SHOREHAM NUCLEAR POWER STATION

SNRC-692

Control Room Design Review
Shoreham Nuclear Power Station - Unit 1
Docket No. 50-322

FIG. 7
SPDS LOCATION—MAIN CONTROL ROOM
SHOREHAM NUCLEAR POWER STATION—UNIT 1

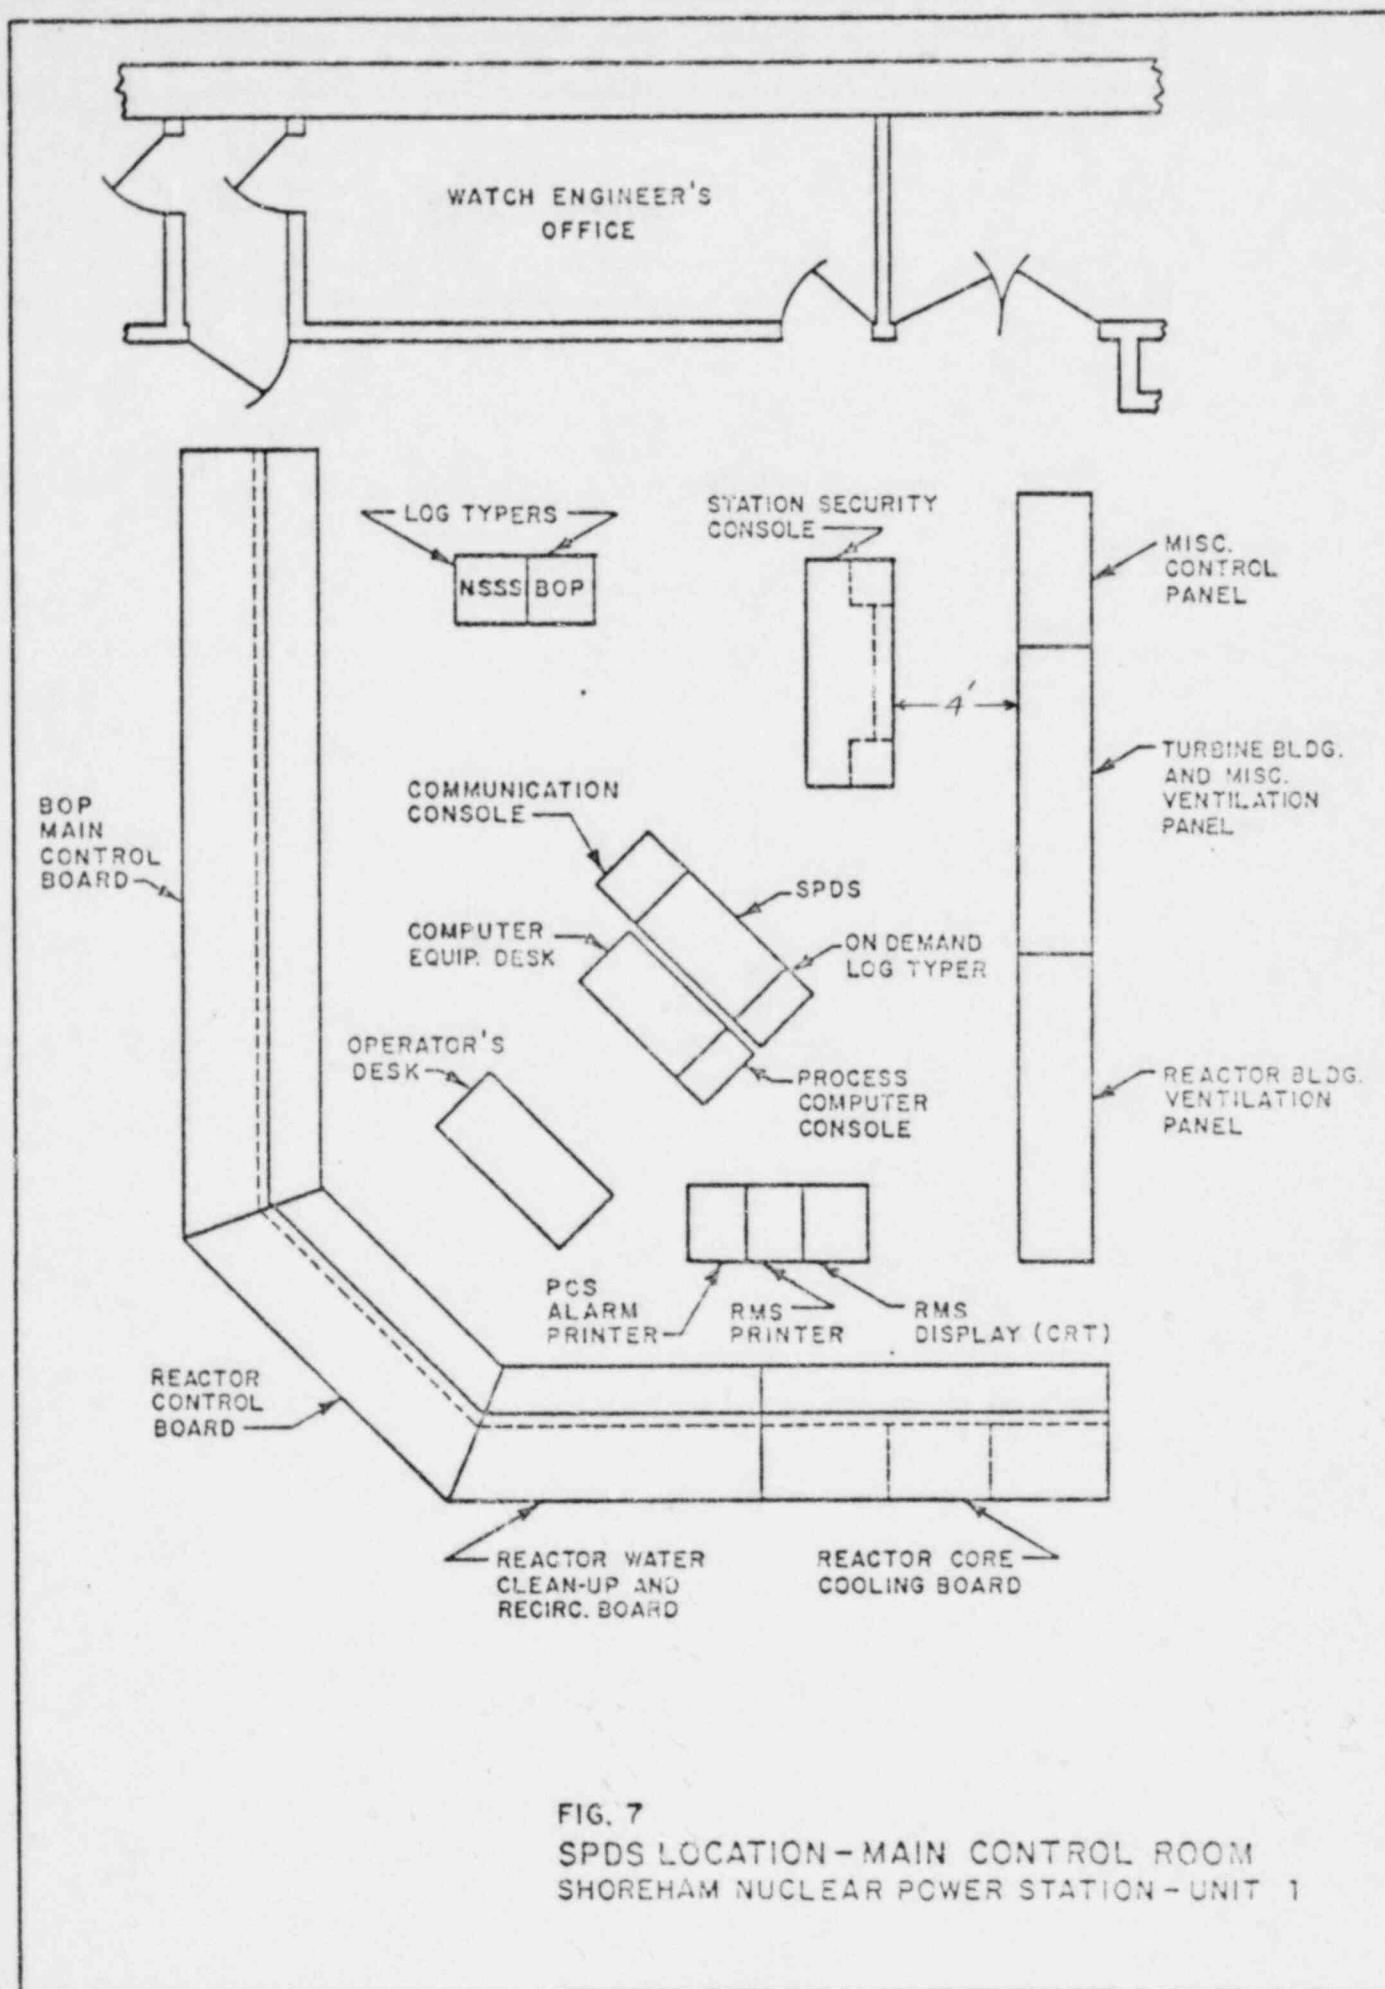
- c) As shown in Figure 7, the SAS is located near the MXP panel (4' clearance). This panel is utilized primarily for certain "support system" controls and indication. Emergency operating procedures do not require the use of the MXP panel. During upset conditions the panel might be utilized by operating personnel for verification of support system response only. A specific task action analysis will be performed during the long term control room design review to further assure that physical interference does not exist between operations personnel and the SAS.
